## Request for Class II Permissive Change

FCC ID: VG8XM131MY Y

Please be notified that we, the undersigned, Guangdong Midea Microwave and Electrical Appliances Manufacturing Co.,Ltd. declare that the reasons for this class II permissive change are as below:

### 1. Updated Motherboard as below:

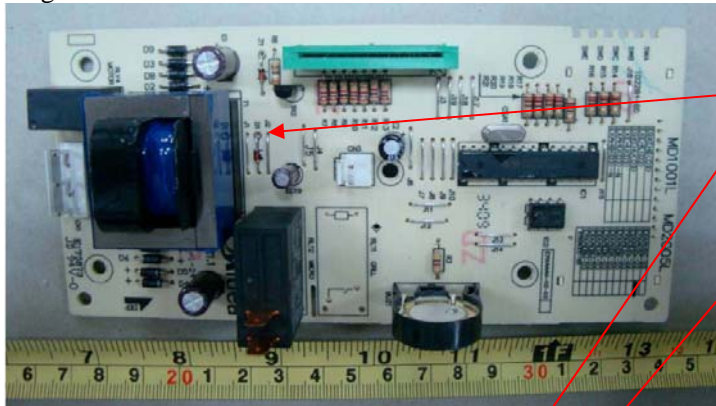
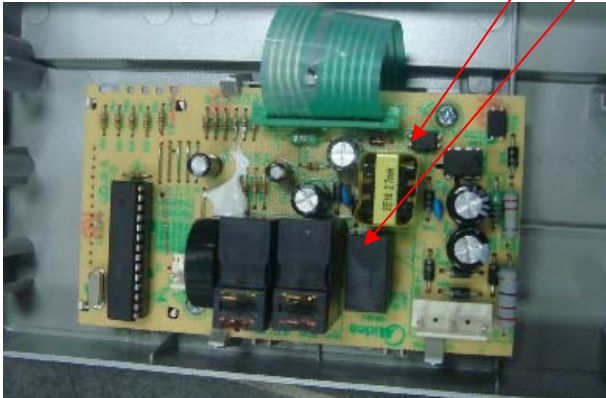
1. Changed linear power supply to switching power supply.
2. Added grill relay .
3. PCB layout is not different as before.
